COUNCIL ASSESSMENT REPORT

Panel Reference No.	2018SNH021
DA Number	LDA 2018/171
LGA	City of Ryde
Proposed Development	Construction of 2 x 15 storey residential apartment buildings comprising 317 dwellings (2 x studio, 104 x 1 bedroom, 179 x 2 bedrooms & 32 x 3 bedrooms apartments) over 3 basement levels of car parking for 308 car spaces together with landscaping works and associated site works.
Street Address	159-161 Epping Road, Macquarie Park
Applicant/Owner	Applicant: 159 Epping Road Pty Ltd C/- Mecone Owner: The Owners Strata Plan 9264
Date of DA Lodgement	4 May 2018
Number of Submissions	One
Recommendation	Approval subject to conditions
Regional Development Criteria - Schedule 7 of SEPP(State & Regional Development 2011)	General Development over \$30 Million
List of All Relevant s4.15(1)(a) Matters	Environmental Planning Instruments • Environmental Planning and Assessment Act 1979; • Biodiversity Conservation Act 2016; • Environmental Protection and Biodiversity Conservation Act 1999; • Sydney Environmental Planning Policy (State and Regional Development) 2011; • State Environmental Planning Policy No. 55 – Remediation of Land; • State Environmental Planning Policy (Infrastru

Figure 9: Relationship between apartment NG03 and its courtyard

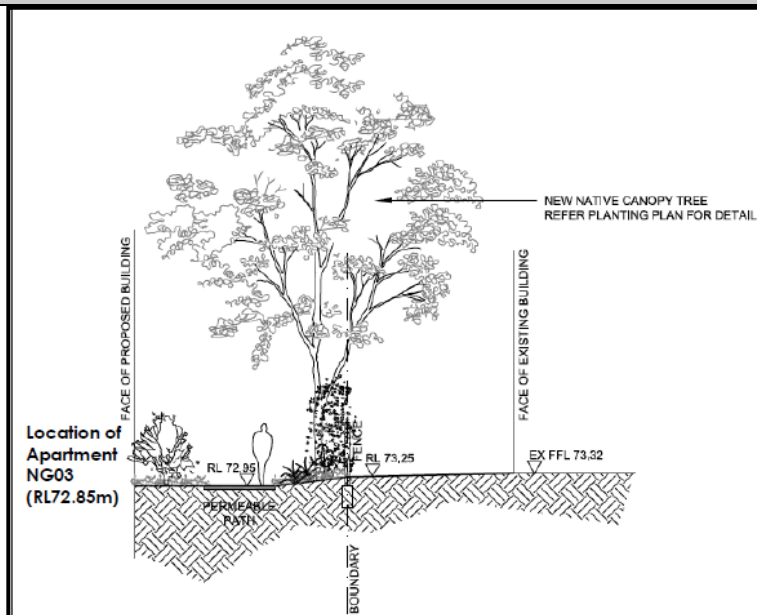
SEPP 65 – Schedule 1 Design Quality Principles	UDRP Comments
	A number of units appear to be below ground level. In particular units SG-06 and NG-01. Generous courtyard depths are supported as they provide space for outlook and to manage levels. More information is needed on site levels and apartments along the boundaries (sections). Comment: <i>The Building Height complies and is discussed in more detail under the Ryde LEP heading further on in this report. In terms of the units appearing to be below ground, please refer to the comments above in this table under the “Built Form and Scale” section regarding this matter.</i>
Density Good design achieves a high level of amenity for residents and each apartment, resulting in a density appropriate to the site and its context. Appropriate densities are consistent with the area’s existing or projected population. Appropriate densities can be sustained by existing or proposed infrastructure, public transport, access to jobs, community facilities and the environment.	Appears to comply with the permissible FSR. Comment: <i>The FSR complies and is discussed in more detail under the Ryde LEP heading further on in this report.</i>

Figure 10: Relationship between apartment NG02 and its courtyard

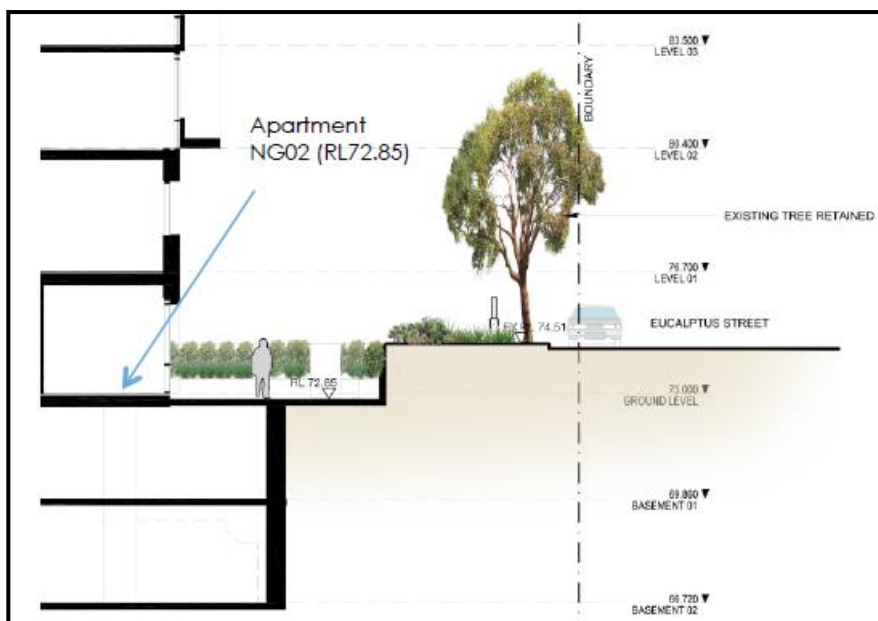
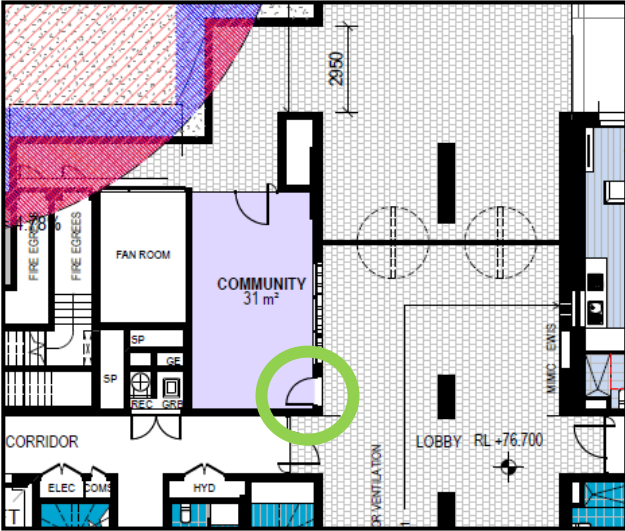
Similarly the boundary addressing Eucalyptus Street is at a level of RL74.51m, while the level of adjoining courtyard of NG02 is RL72.95m, being a difference of 1.56m (see Figure 10). To ensure the apartments are provided with sufficient amenity, the floor to ceiling heights are increased to 3.3m, and the depth of the courtyard is 4.3m deep which allows for acceptable ventilation. Furthermore, as this apartment faces north-east, it also achieves good solar access.

Figure 15: Section drawing showing maximum height limit represented by red dashed line (Source: Warren and Mahoney)

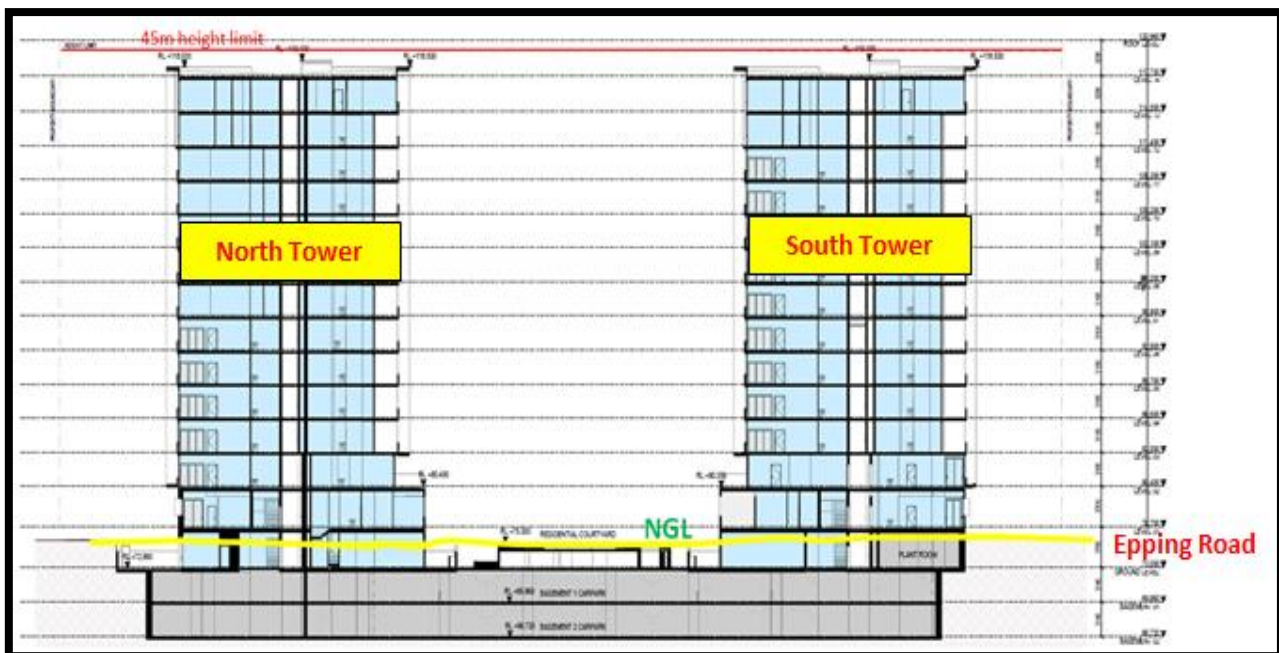
A maximum building height limit of 45 metres applies to the development site. Although there is cross fall over the site, both towers sit within the maximum building height limit. The site has an existing ground RL of 74.25 at the lowest point relative to the North Tower and an RL of 73.23 at the lowest point relative to the South Tower.

The maximum height of the North Tower is RL119.1 at the top of the lift overrun, resulting in a maximum building height of 44.85 metres, and the maximum height of the South Tower is also RL119.1 at the top of the lift overrun, resulting in a maximum building height of 45m as measured from the existing natural ground level, which is illustrated in **Figures 15, 15A and 15B**.

Figure 16: Tree removal and retention plan (Source: TaylorBrammer).

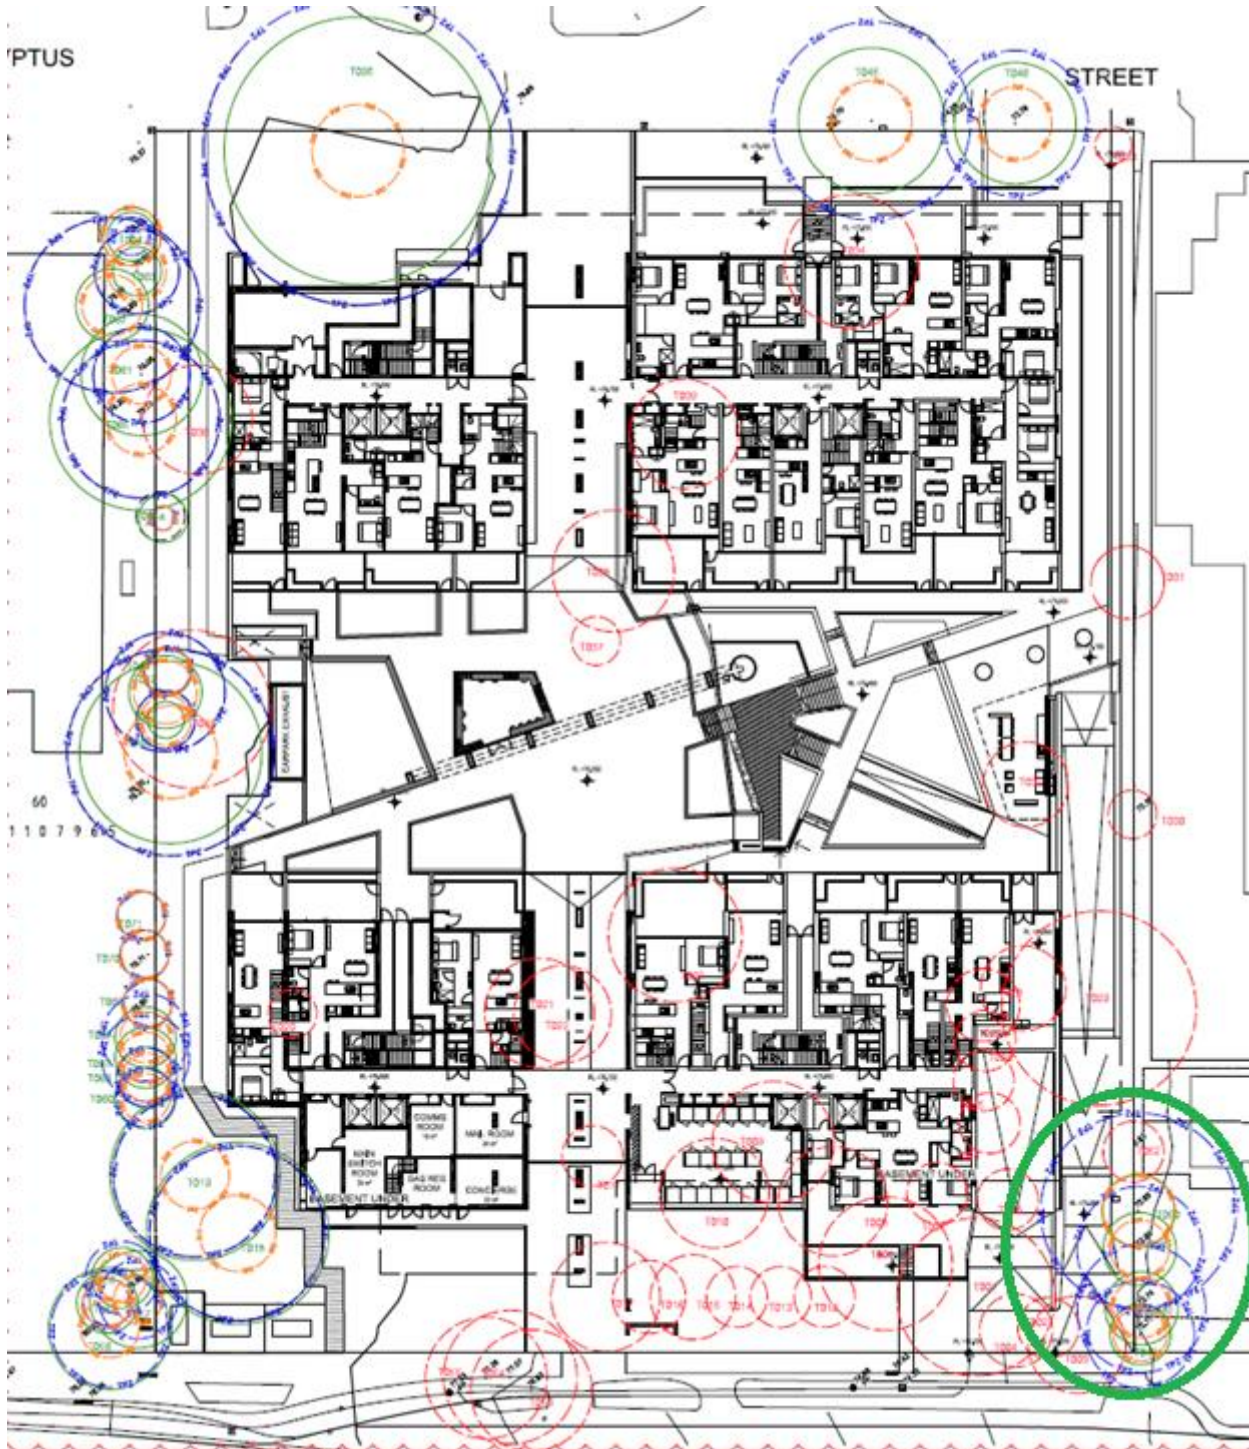
Note: The thick green circled area indicates Conifer trees to be removed (Trees 47 to 50) from the adjoining lot as a result of site works.

Figure 1: Tree Retention & Removal Plan Extract – April 2018 (Source: Travers Bushfire and Ecology 2018)

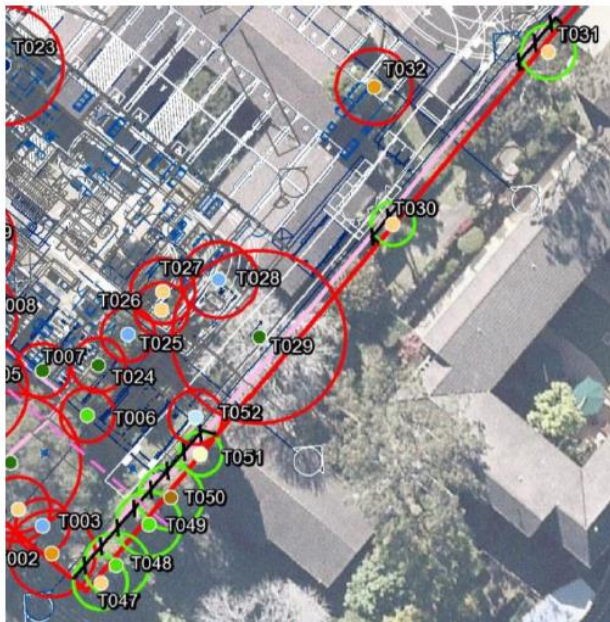
Concern still exists, however, in relation to the impacts and proposed retention/removal of Trees 47, 48, 49, 50 & 51 (*Cupressus* sp.) located adjacent to the south eastern boundary of the subject site. It is noted that the previously submitted Tree Assessment dated 13 April 2018 had shown these trees located on the neighbouring allotment and marked for retention (see Figure 1), however the amended Tree Assessment dated 29 October 2018 has shown these trees located on the subject site and marked for removal (see Figure 2). In addition, it is noted that a similar anomaly has occurred in relation to the proposed retention/removal of Tree 31 (*Corymbia maculata*) whereby the Tree Assessment dated 13 April shows it located on the neighbouring allotment and marked for retention (see Figure 1) as opposed to the updated Tree Assessment dated 29 October which shows it located on the subject site and marked for removal (see Figure 2). Images taken on site by CPS show these trees located on the neighbouring side of the existing fence line (see Figures 3 & 4) however it is understood the alignment of the fence may not necessarily be in keeping with the cadastral boundary. As such, it is considered that this issue is still outstanding and that further information is required to be submitted by the applicant as to the clarify the exact location and subsequent ownership of these trees. If these trees are deemed to be located on the neighbouring allotment, they must be considered a priority for retention and design changes will be required to reduce the impact of the proposed driveway and basement footprints on their TPZ and SRZ.
